Project	<b>IEEE 802.16 Broadband Wireless Access Working Group</b> < <a href="http://ieee802.org/16">http://ieee802.org/16</a> >	
Title	<b>Supplemental material for TGD comments</b>	
Date Submitted	<b>2004-04-15</b>	
Source(s)	<p>Itzik Kitroser  Yossi Segal  Yigal Leiba  Zion Hadad  Runcom Technologies Ltd.  2 Hachoma St. 75655  Rishon Lezion, Israel</p>	<p>Voice: +972-3-9528440  Fax: +972-3-9528805  <a href="mailto:itzikk@runcom.co.il">mailto:itzikk@runcom.co.il</a>  <a href="mailto:yossis@runcom.co.il">mailto:yossis@runcom.co.il</a>  <a href="mailto:yigall@runcom.co.il">mailto:yigall@runcom.co.il</a>  <a href="mailto:zionh@runcom.co.il">mailto:zionh@runcom.co.il</a></p>
Re:	802.16-REVd Sponsor ballot recirc	
Abstract	This document contains supplemental material for 802.16-REVd sponsor ballot	
Purpose	Adopt suggested changes into P802.16-REVd/D4 draft	
Notice	This document has been prepared to assist IEEE 802.16. It is offered as a basis for discussion and is not binding on the contributing individual(s) or organization(s). The material in this document is subject to change in form and content after further study. The contributor(s) reserve(s) the right to add, amend or withdraw m

**Figure 209—Example of the data region which defines the OFDMA allocation**

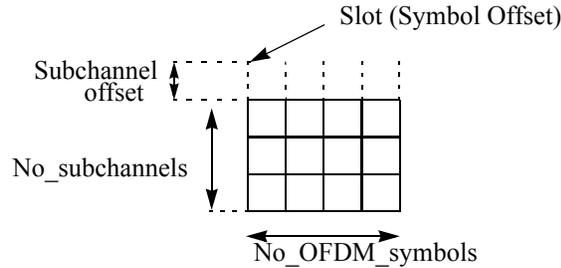
Comment #257. The current OFDMA PHY contain usage of concepts as Zone and a Segment which are not clearly defined anywhere. A clear definition of the terms is required for a consistency reasons. In addition the OFDMA data mapping referes to FEC block, while the correct term is OFDMA slot.

**[Page 465, line 25, section 8.4.3, change:]**

In OFDMA, a Data Region is a two-dimensional allocation of a group of contiguous subchannels, in a group of contiguous OFDMA symbols. This allocation may be visualized as a rectangle, such as the 4x3 rectangle shown in Figure 209.

Figure 213—Time plan - one TDD time frame (with only mandatory zone)

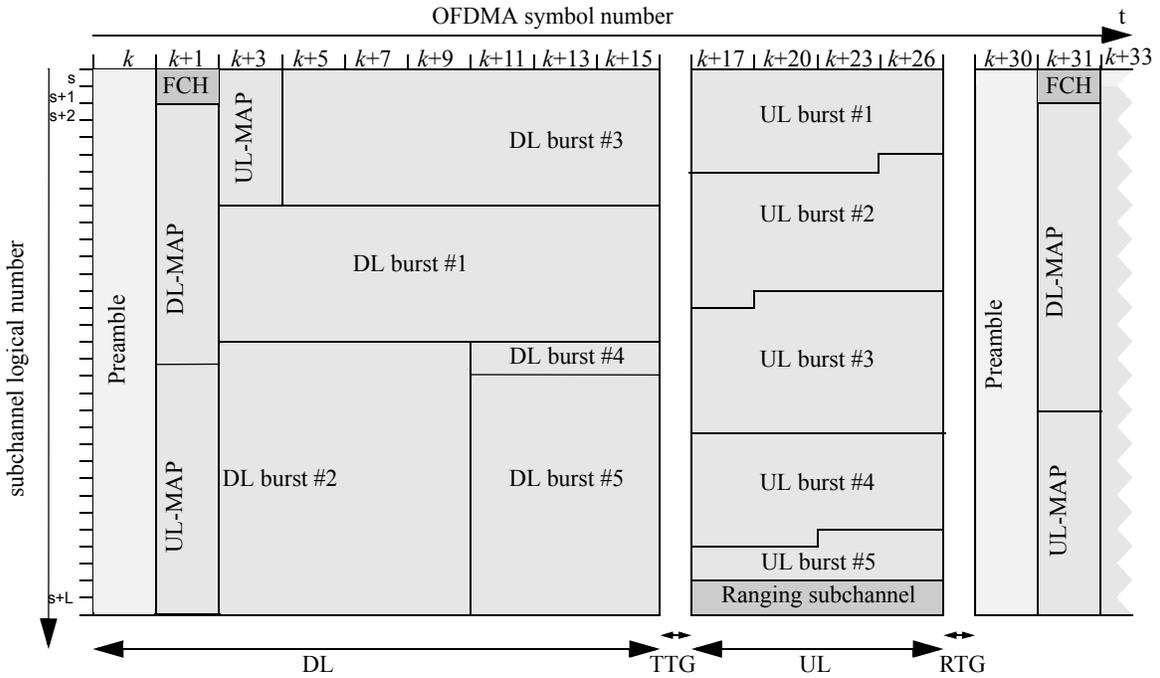
Comment #350 changed the UL allocating scheme to a uni-dimensional scheme. This means that the UL allocations are no longer rectangles, this should be reflected in figure 213. In addition figure 213 does not provide a clear example of the OFDMA frame with multiple zones.

[Page 468, line 5, section 8.4.4.2, change figure 213 (and title) as follows:]

**Figure 215—FCH subchannel allocation for all 3 segments**

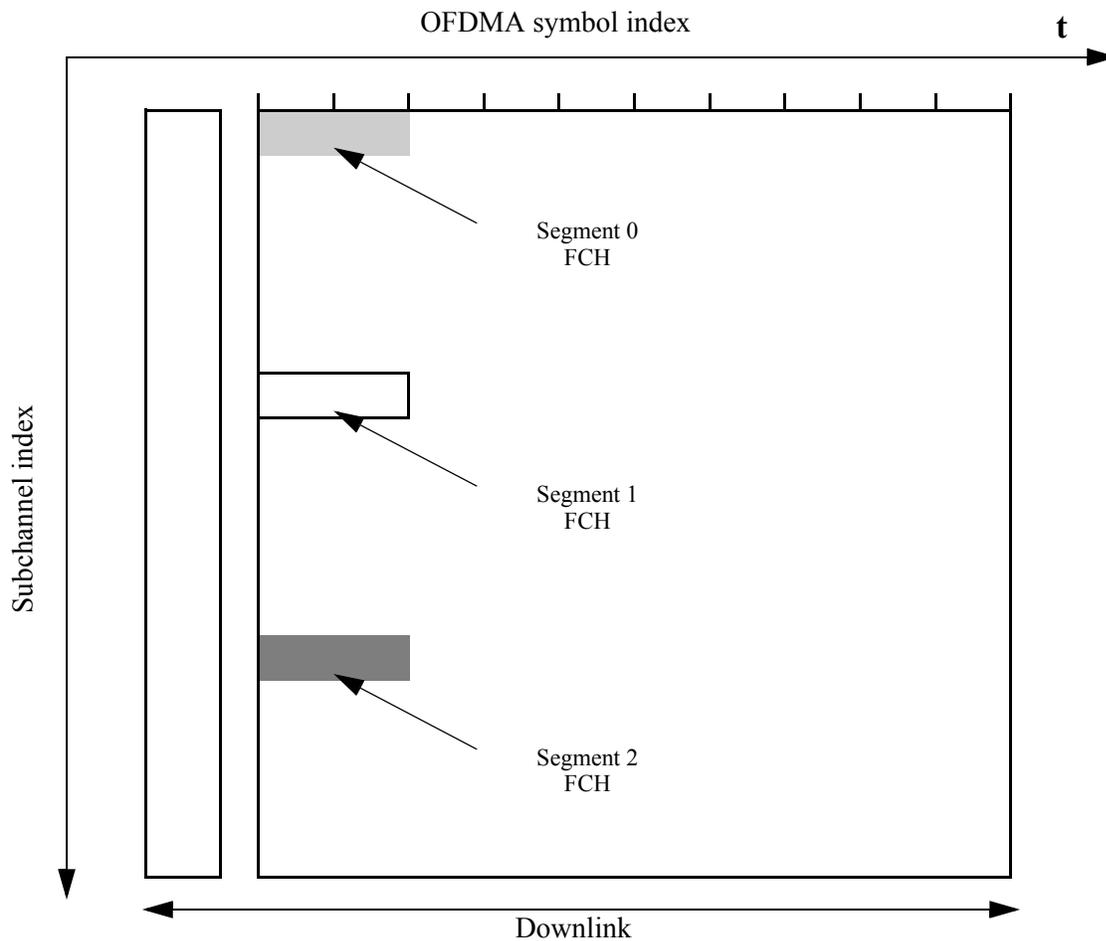
In addition, figure 215 describes the FCH as transmitted over one OFDMA symbol and two subchannels, and should be two OFDMA symbols over one subchannel.

**[Page 471, line 4, section 8.4.4.5, replace figure 215 with the following figure]**

Figure 216—Example of renumbering the allocated subchannels for segment 1 in PUSC

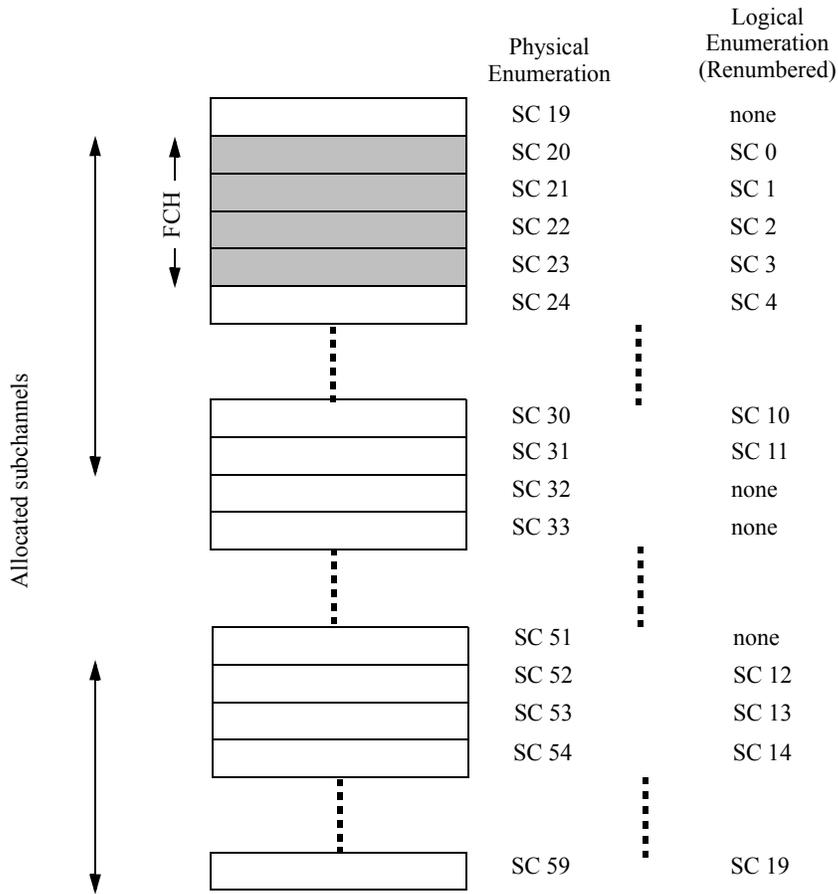
The example given in figure 216 is wrong, since the standard defines that the FCH is transmitted using a duration of 4 OFDMA subchannels.

**[Page 472, line 2, section 8.4.4.5, Change figure 216]**

Figure 217—Example of UL renumbering the allocated subchannels for a segment in PUSC

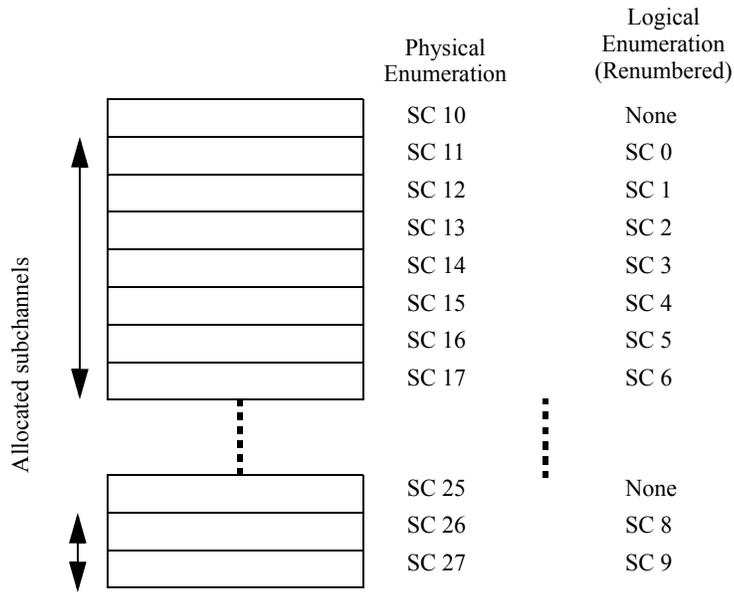
The current subchannels renumbering definition for the UL stating that "no renumeration is done" is wrong, since obviously a renumbering scheme is required.

[Page 472, line 2, section 8.4.4.5, Insert new figure 217]

Figure 235— STC usage with OFDMA for FUSC

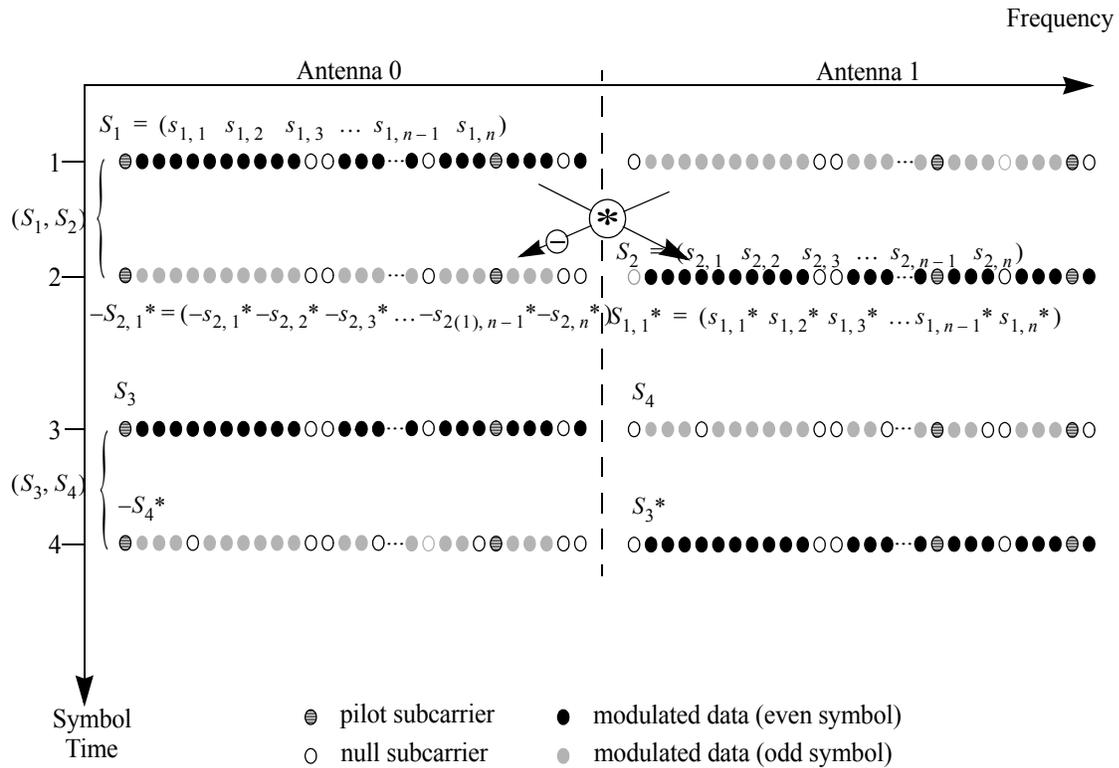
Comment #362 contained instruction to change figure 235, this comment wasn't implemented due to an unclear instruction, this comment provide the required changes. In addition, the existing figure is relevant for FUSC only, an additional figure is required for the PUSC case.

[Page 519, line 3, section 8.4.8.2.1, change figure 235 as indicated, change title to make figure relevant to FUSC]
